Meeting Summary

Section 1 - Kennedy Interchange & Section 4 - East End Kentucky Approach Regional Advisory Committee Meeting October 26, 2006

Lighting concept for Floyd Street structure

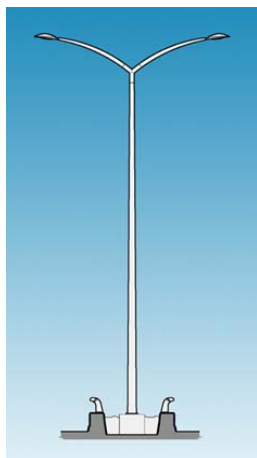
8C. With the issue of lighting, the KHPAT saw the lighting concepts and they were opposed because the under path lighting looks very unsafe.

3' Barrier with Rail

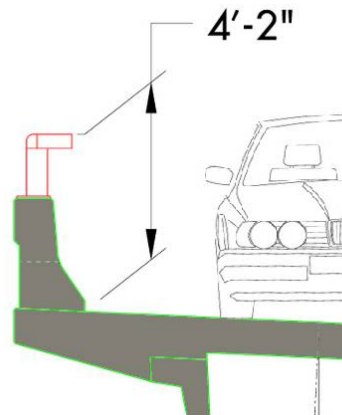
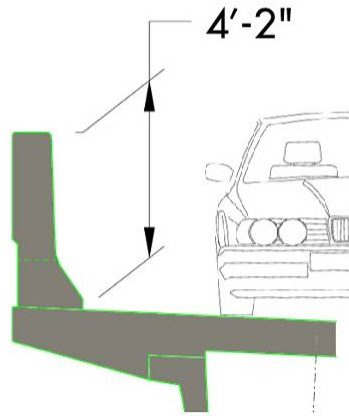
9C. With the railings, the concrete block precludes a lot of visual aspects. I find it hard to think people would like the concrete railing.
